STAFF RECOMMENDATION
2507 Essex Place
September 18, 2013

Application: New construction – addition and outbuilding
District: Hillsboro-West End Neighborhood Conservation Zoning Overlay
Council District: 18
Map and Parcel Number: 10411028000
Applicant: Van Pond, Architect
Project Lead: Sean Alexander, sean.alexander@nashville.gov

<p>Description of Project: The applicant is proposing to construct a rear addition to the house at 2507 Essex Place and an outbuilding.</p> <p>Recommendation Summary: Staff recommends approval of the application to construct a rear addition and a new outbuilding at 2507 Essex Avenue with conditions that the driveway be retained to least the midpoint of the structure or eliminated, and that final drawings with major measurements called out be submitted to staff, finding the application to meet the applicable design guidelines for new construction in the Hillsboro-West End Neighborhood Conservation Zoning Overlay.</p>	<p>Attachments A: Photographs B: Site Plan C: Elevations</p>
---	--

1 Proposed Site Plan

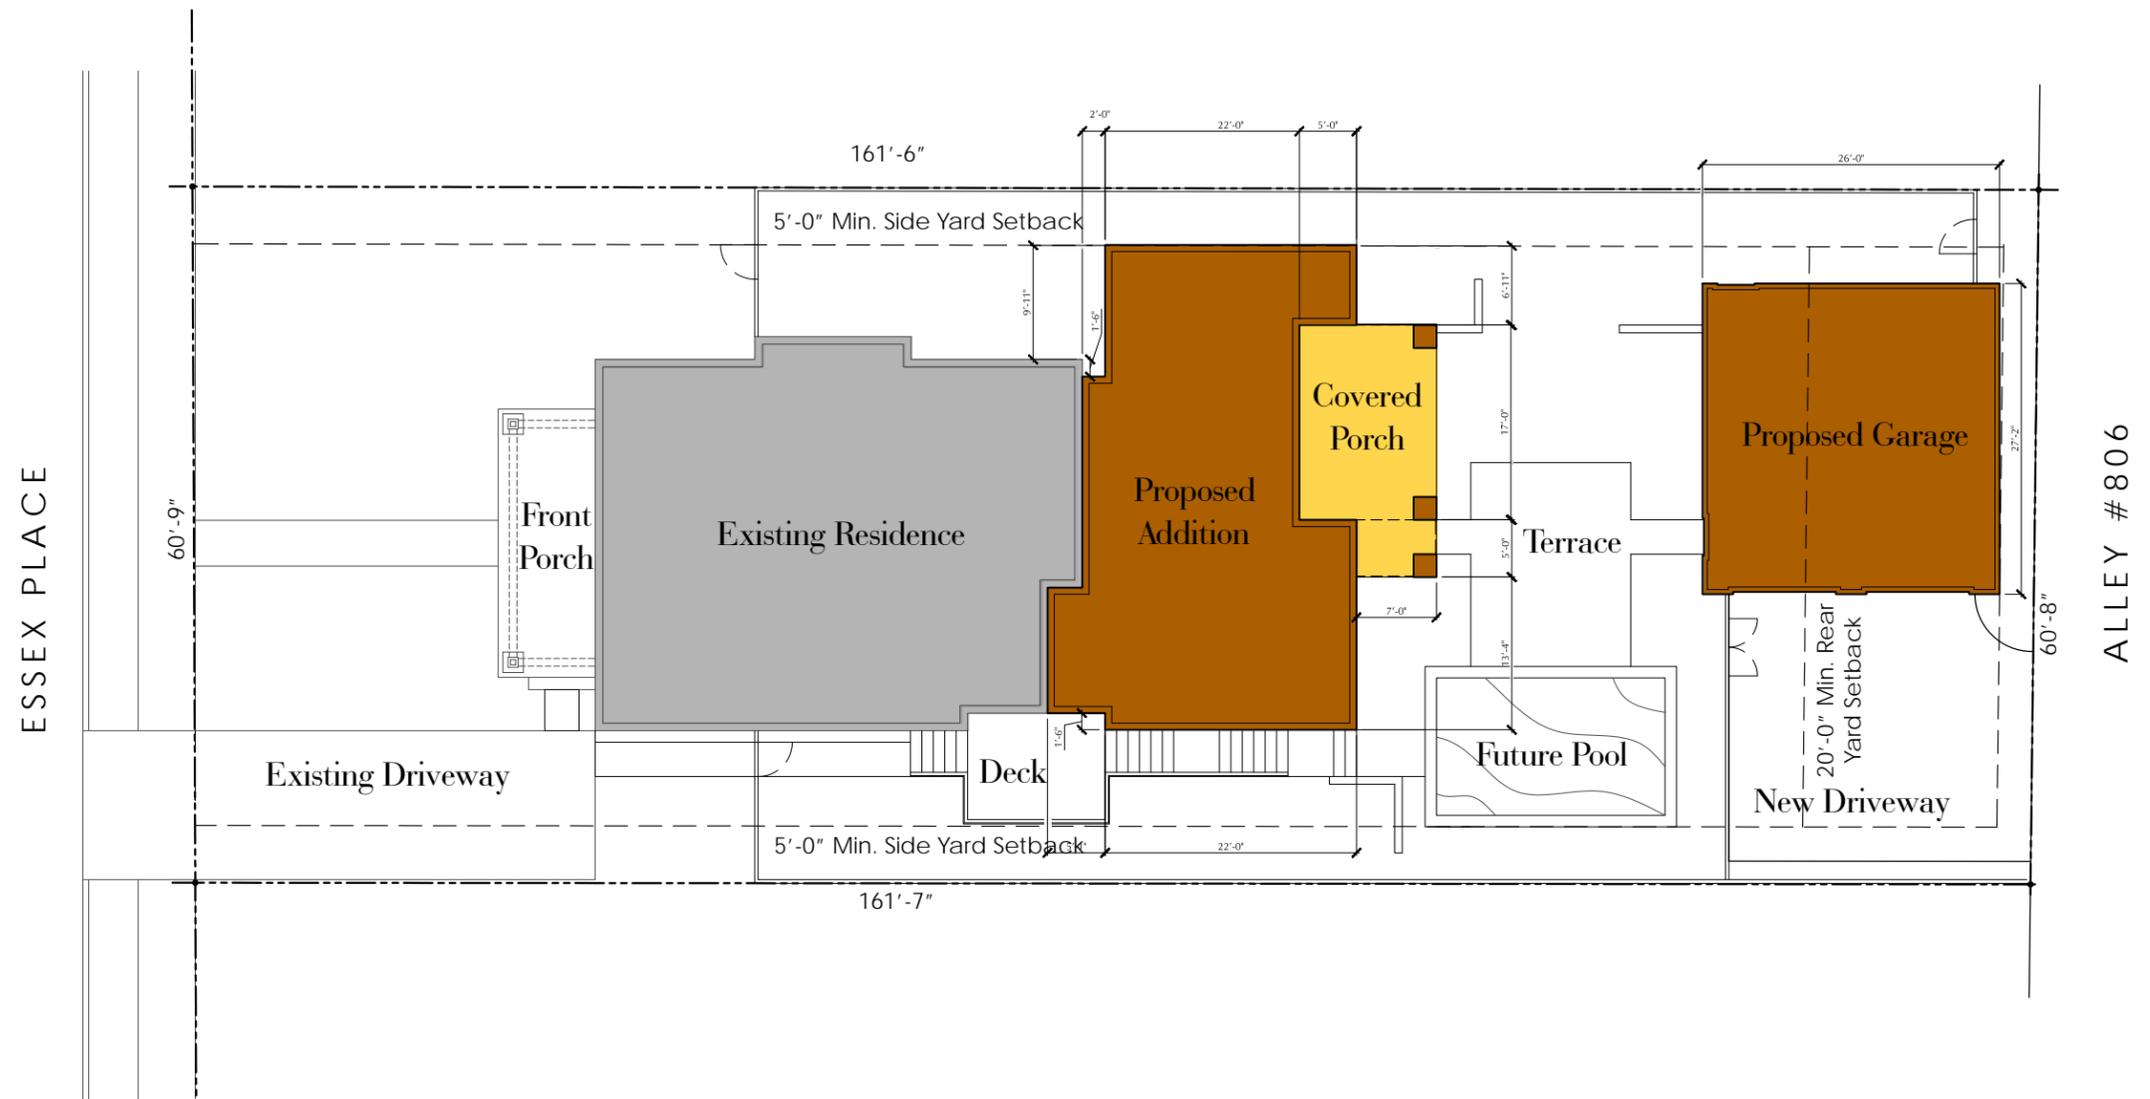
The orientation of the primary building will not change. The vehicular orientation will be moved to off the alley, as seen historically. A portion of the existing driveway will be

removed to make room for the addition, leaving a section of driveway that ends at the front wall of the house. Typically, the Commission requires that driveways extend as far as the mid-point of the house so that the driveway is not just a front-yard parking pad. Staff recommends that the driveway be retained to least the midpoint of the structure or eliminated its entirety so as to not create this scenario.

The new outbuilding will be located behind the house, three feet (3') from the rear and eight feet (8') from the left side property lines. The building will have two garage doors on the right side elevation, facing the interior of the lot. Although there is an existing driveway from the street, the new building will be accessed from the alley. This is an appropriate location for outbuildings, meets the current setback requirements, and meets guideline II.B.1.h.2.

Staff recommends approval of the application to construct a rear addition and a new outbuilding at 2507 Essex Avenue with conditions that the driveway be retained to least the midpoint of the structure or eliminated, and that final drawings with major measurements called out be submitted to staff, finding the application to meet the applicable design guidelines for new construction in the Hillsboro-West End Neighborhood Conservation Zoning Overlay.

1 Proposed Main Floor Plan

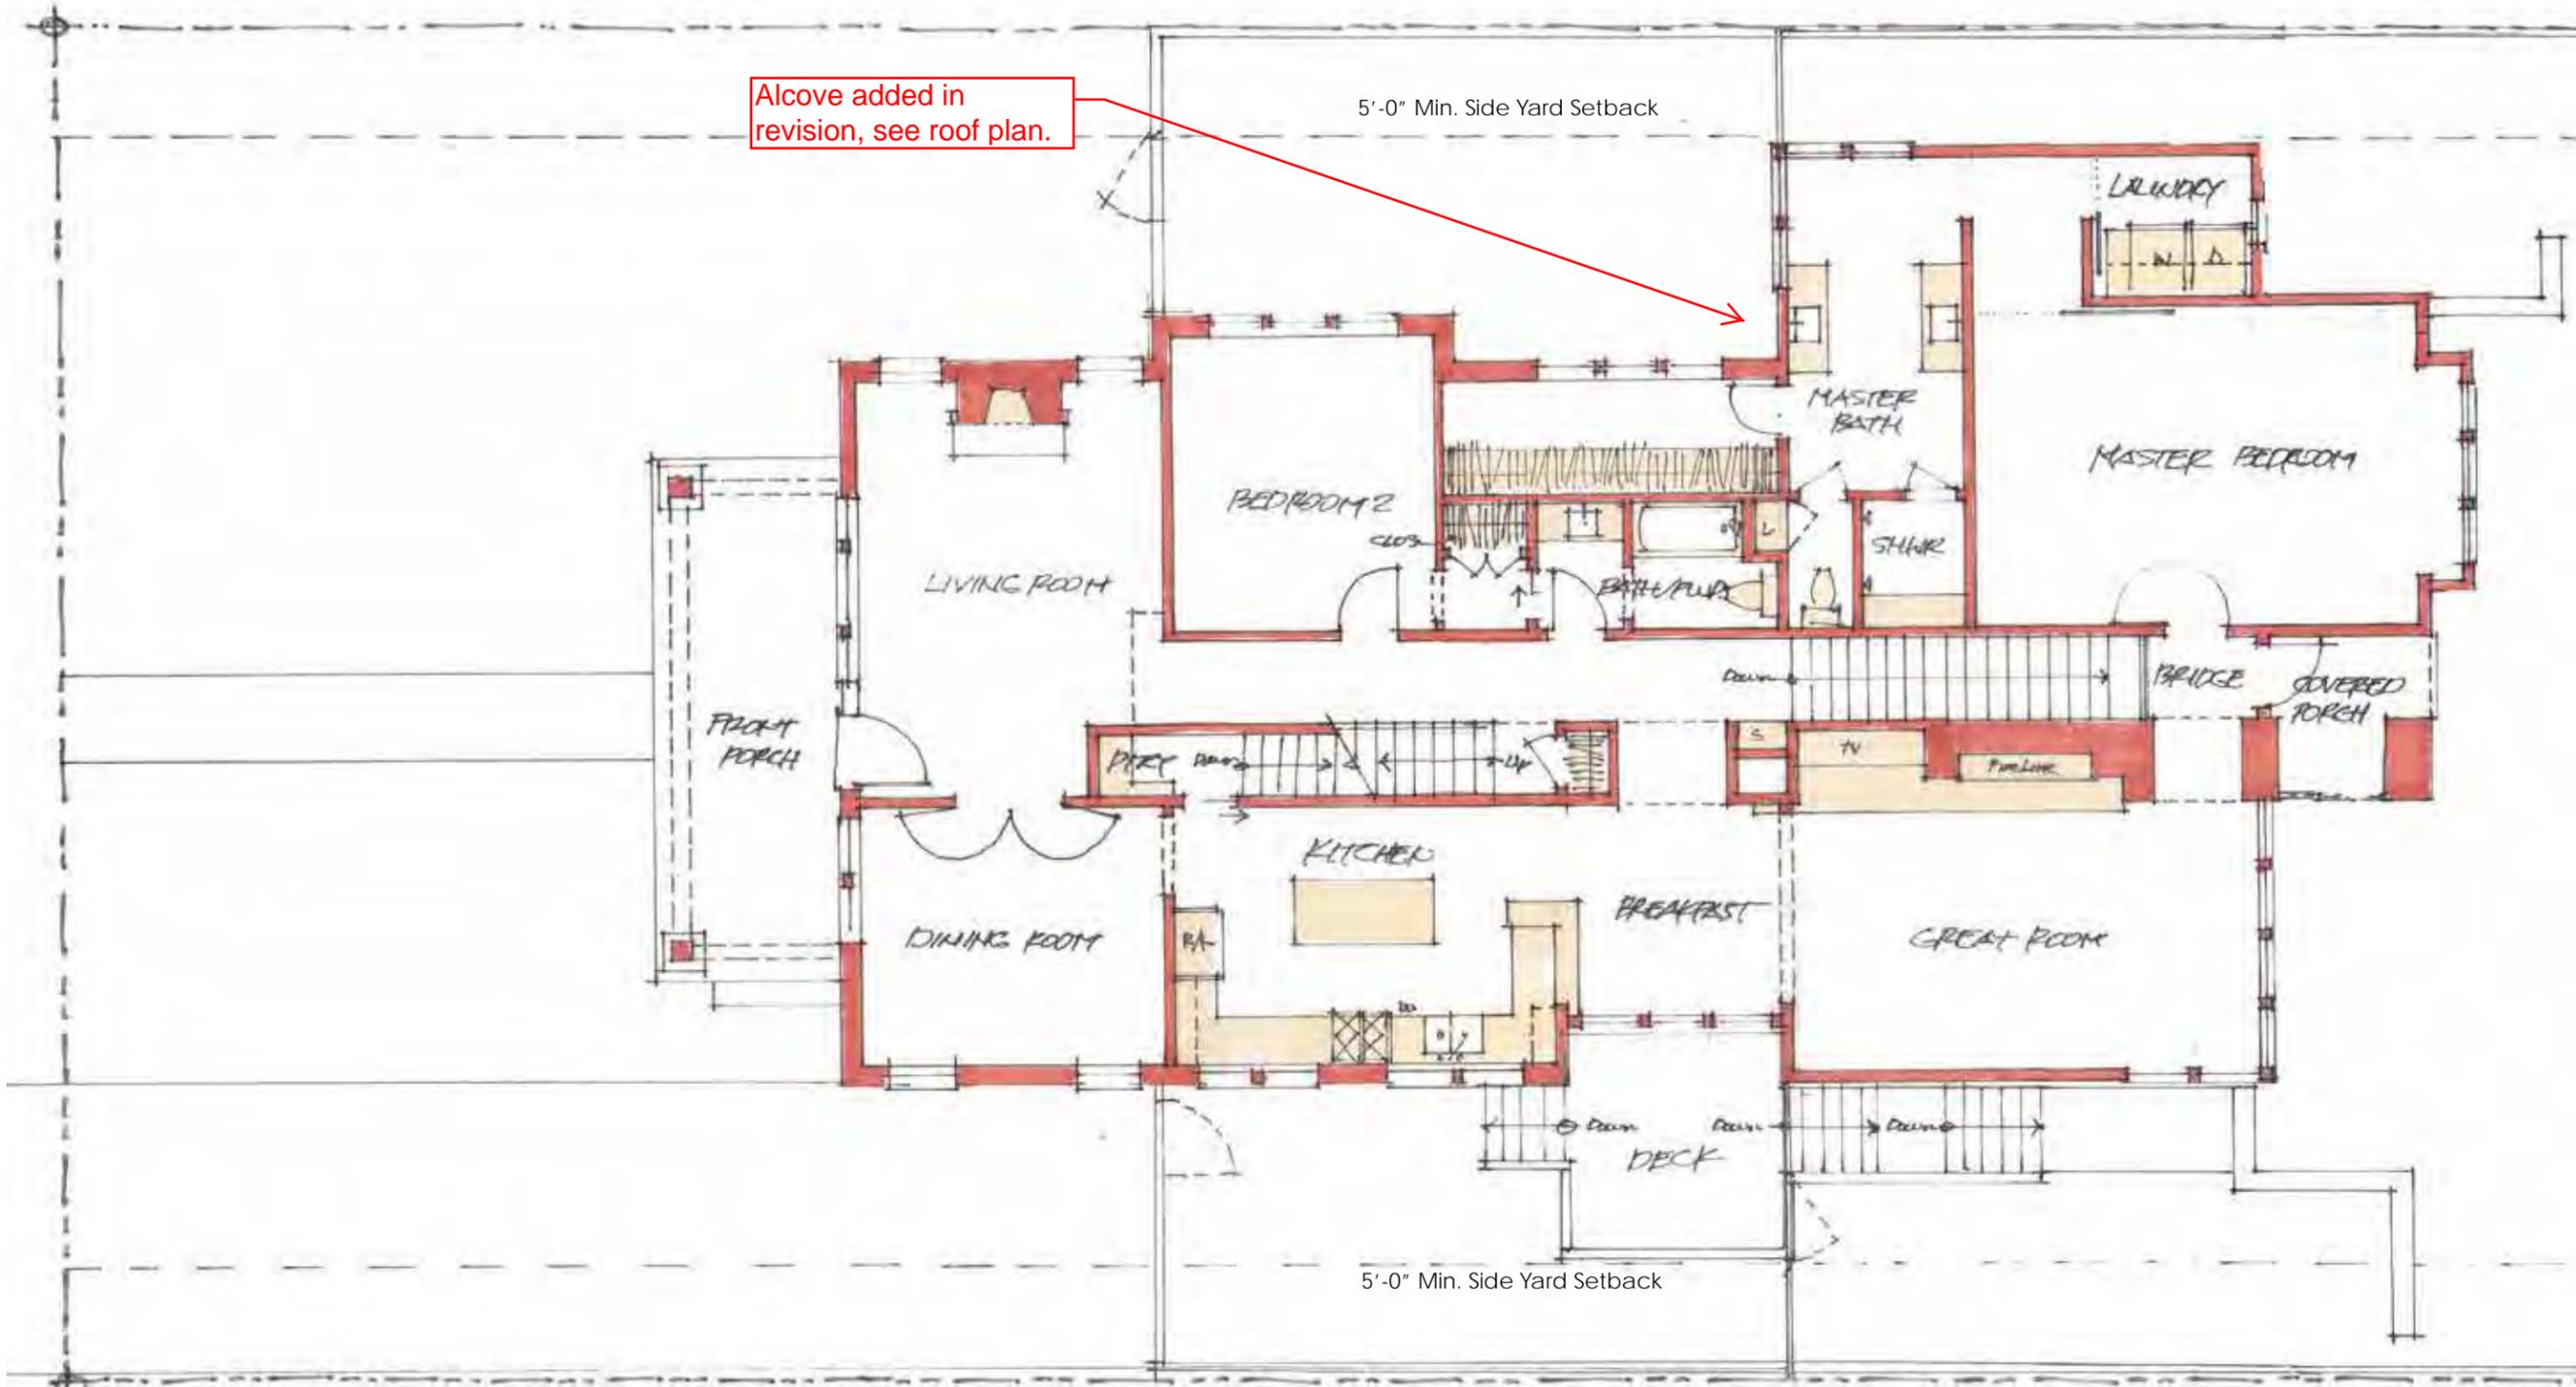
The addition will extend the depth of the house by twenty-four feet (24'), with a covered porch continuing an additional eight feet (8') to the rear. On the right side the addition will continue in line with the outside wall of the enclosed rear porch, creating an eighteen inch (18" x 12') alcove before stepping out flush with the main wall.

On the left side the addition will also have an alcove stepping in eighteen inches (18") for a length of two feet (2'), then stepping out ten feet (10') to the left. Generally, an addition wider than an historic structure is not appropriate. However, the existing house is more than ten feet (10') narrower than the typical historic house in the surrounding area; therefore staff finds the width of the proposed addition to be appropriate. In addition, the impact of the projection will be minimal since the additional width begins forty-five feet (45') back from the front wall of the house, and will project only eight feet (8') beyond the silhouette of the house on the left side.

The addition will not alter the setback or rhythm of spacing on the right side because it will not extend beyond the existing wall of the house. On the left side, by projecting beyond the silhouette of the house, the outside wall of the addition will sit five feet (5') from the property line. The distance from the wall of the addition to the adjacent structure will be no less than twelve feet (12'). Staff finds that the addition, which at the widest point will be forty-two feet (42') wide, will maintain the rhythm of spacing and setbacks established by the surrounding historic buildings and will meet guideline II.B.1.c.

① Proposed Garage Floor Plan

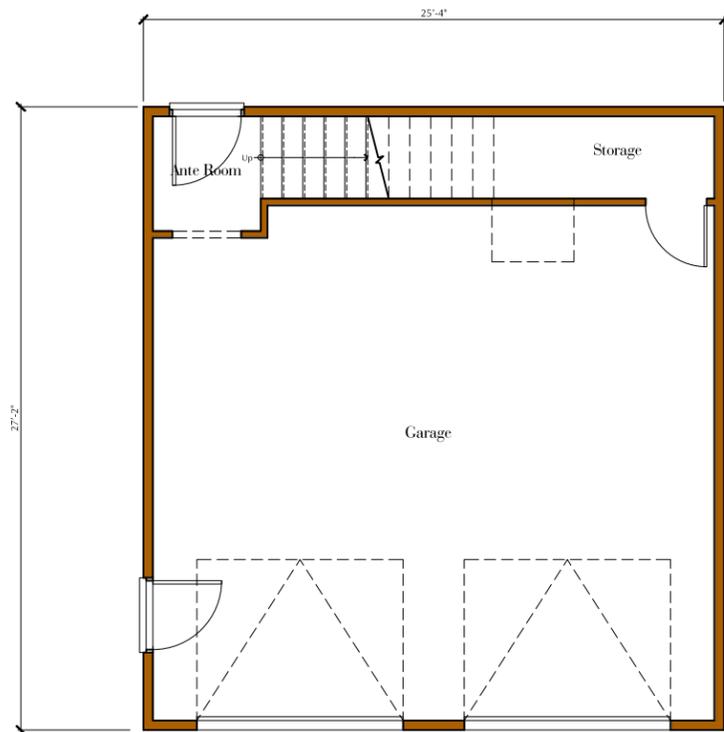
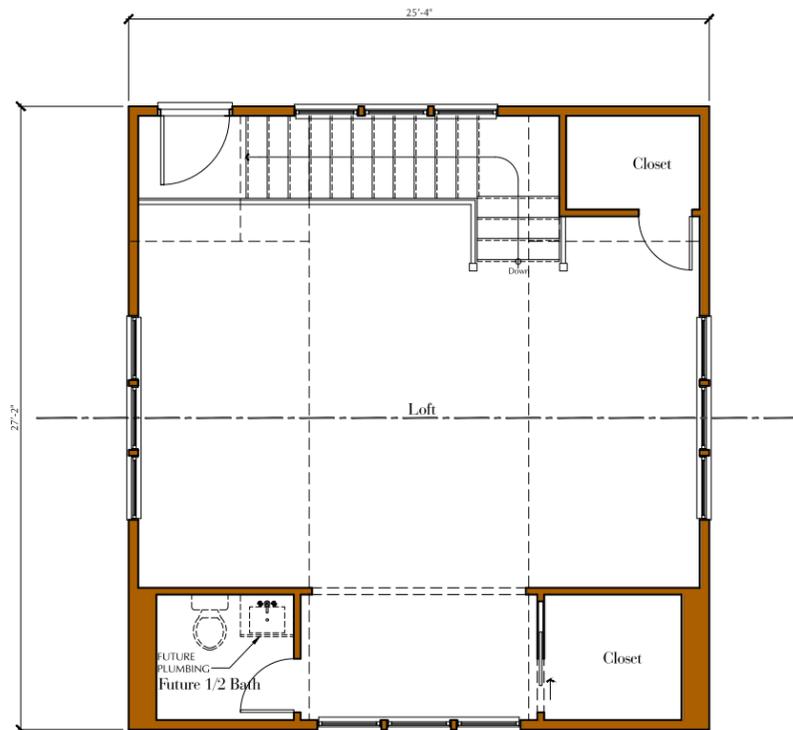
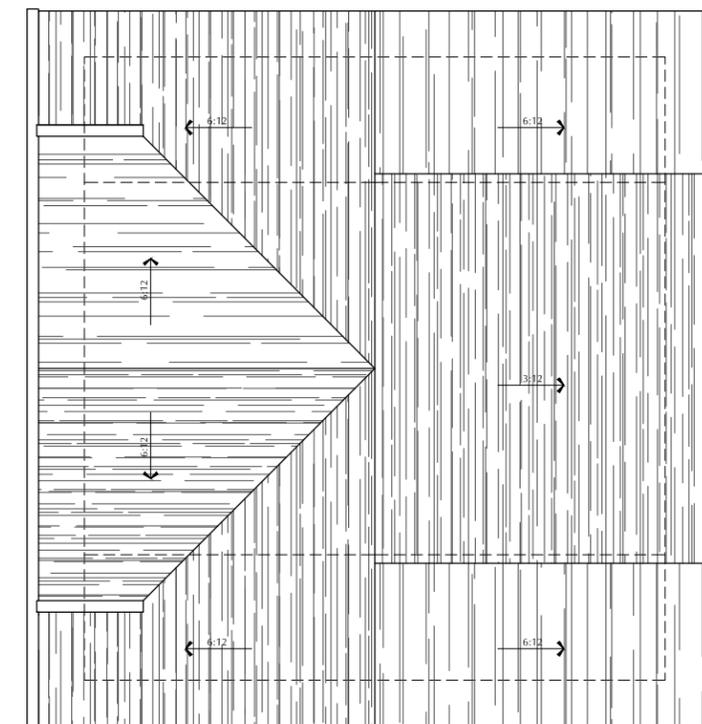
The new outbuilding will be one and one-half stories tall, with a two-car garage on the first story and a "bonus room" above. The roof of the garage will have an apex at twenty-one feet (21') above grade, with an eave height of twelve feet, six inches (12'-6"). These heights are subordinate to the roof of the house is twenty-four feet tall, and the heights of the eaves of the house vary with grade from twelve feet (12') at the front to fifteen feet (15') at the rear. The grade at that rear of lot is as much as eight feet (8') lower than the front which will help to further ensure that the scale of the building is subordinate to the house. The footprint of the building will be less than seven hundred square feet (700 sq. ft.), which is compatible with historic buildings in the area and also helps with keeping an appropriate scale. Staff finds that the height and scale of the proposed outbuilding will meet guideline II.B.1.h.1.

The materials of the outbuilding will match those of the addition: composite shingle roof, cement-fiberboard clapboard siding with vertical wood "strapping" or half-timbering, a wood drip-edge at the floor level, cement-fiberboard panels, a parged concrete foundation wall, and wood windows. The roof will also be a 6:12 gable with a gabled dormer on the north elevation (facing the house) and a shed-roofed dormer on the south elevation (facing the alley). These materials and roof form are compatible with the historic house and meet guideline II.B.1.h.1.
